Title : **CLOCK PHASE DETECTING CIRCUIT AND CLOCK
REGENERATING CIRCUIT EACH ARRANGED IN
RECEIVING UNIT OF MULTIPLEX RADIO EQUIPMENT**

PETITION UNDER 37 CFR 1.181(A)
REQUESTING
WITHDRAWAL OF HOLDING OF ABANDONMENT

AMENDMENT UNDER 37 C.F.R. § 1.173(b)

FIG. 14

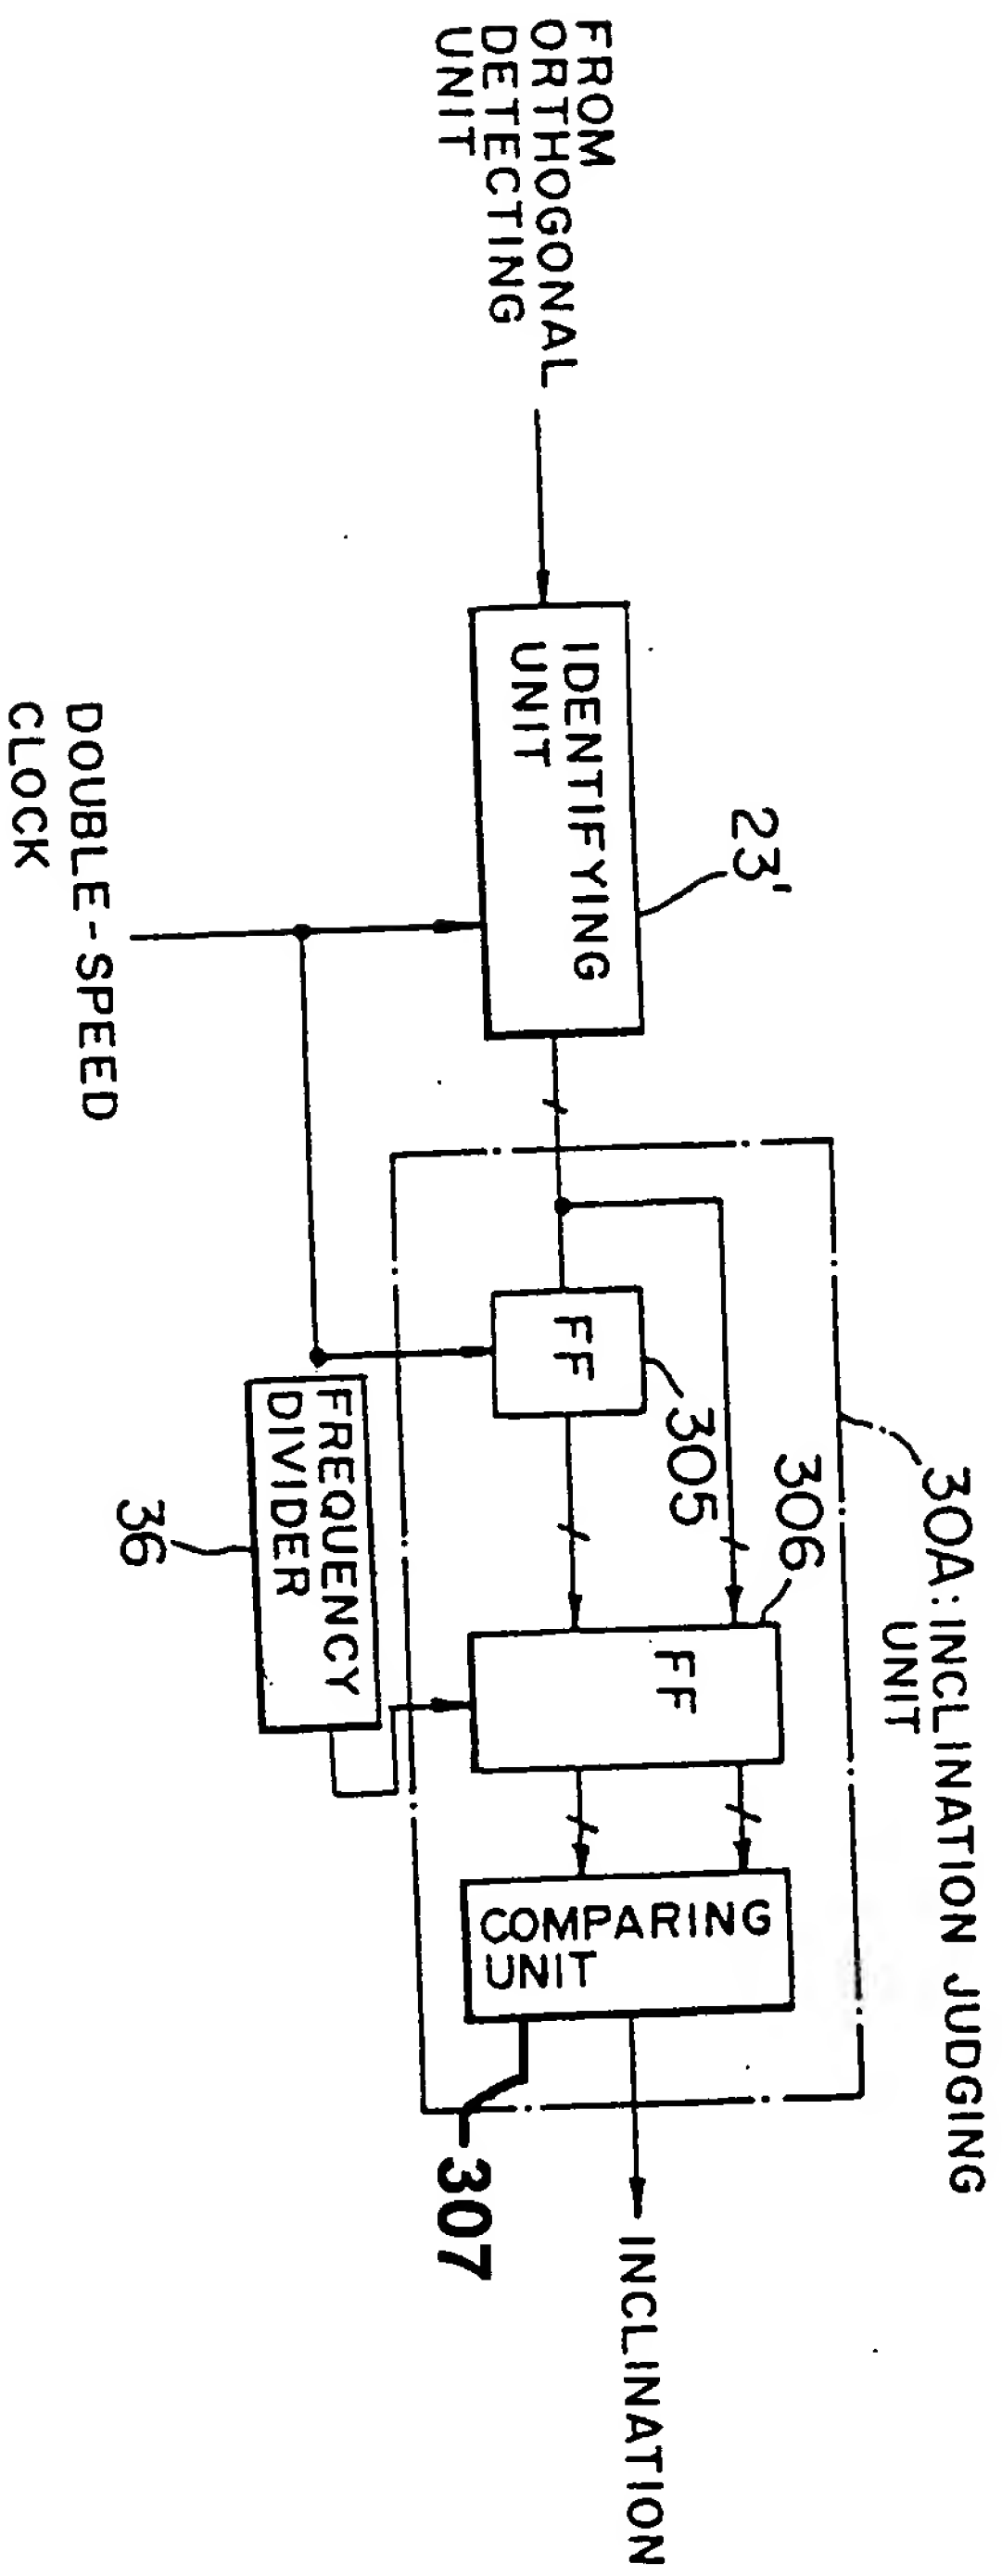
FIG. 14 objected to under 37 C.F.R. § 1.84(p)(5) for failing to include reference sign 307, which is mentioned in the specification at column 26, line 34. Applicants attach clean and marked-up versions of a proposed amended FIG. 14 to include reference sign

307. Accordingly, Applicants respectfully request approval of the proposed changes, and withdrawal of the drawing objection.
